Final Environmental Impact Report
No. GPA22-00001

Pacifica Development Project

SEPTEMBER 2023

2 Responses to Comments

Attachment A – Existing Traffic Patterns – Replica

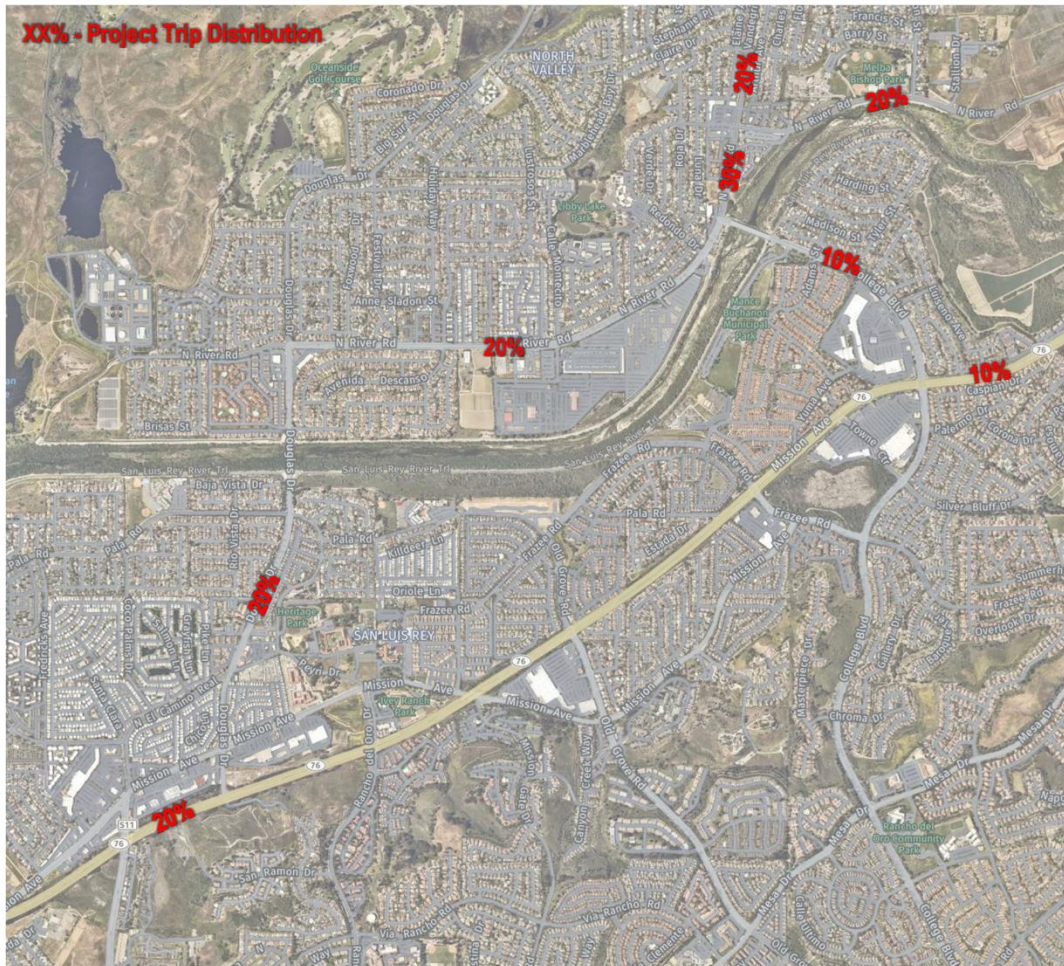
- In the Local Transportation Study section 3.2 Project Trip Distribution and Assignment, please provide further details regarding the project trip distribution. Additionally, please provide the trip distribution at any locations on SR-76 with project trips.

- A2-2** The comment provides no substantial evidence of a significant environmental impact. The comment requests further details regarding project trip distribution as well as, trip distribution at any locations on SR-76. Consistent with the *City of Oceanside Traffic Impact Analysis Guidelines, August 2020*, since the project does not generate more than 2,400 average daily trips (ADT) a select zone analysis via SANDAG Regional Travel Demand Model is not required. Instead, the project trip distribution was manually developed based on the geographical location of the Project, as well as the characteristics of the proposed and surrounding land uses.

- Additionally, a review of existing travel patterns for the project site's traffic analysis zone (TAZ) was completed using Replica big data¹ hosting services. Per Replica's big data hosting services, it was estimated that the majority of existing trips from the project site's TAZ would travel north along Vandegrift Boulevard, east along N. River Road, and south along N. River Road. Additionally, based on the project's location, a small amount of project traffic is expected to travel north of the project site along Monica Circle, east along Macario Drive, and south along Roja Drive.

- Attachment A displays existing traffic patterns per Replica big data hosting services. Attachment B displays the assumed project trip distribution at locations along SR-76. Attachment C displays the assumed project trip assignment at locations along SR-76.
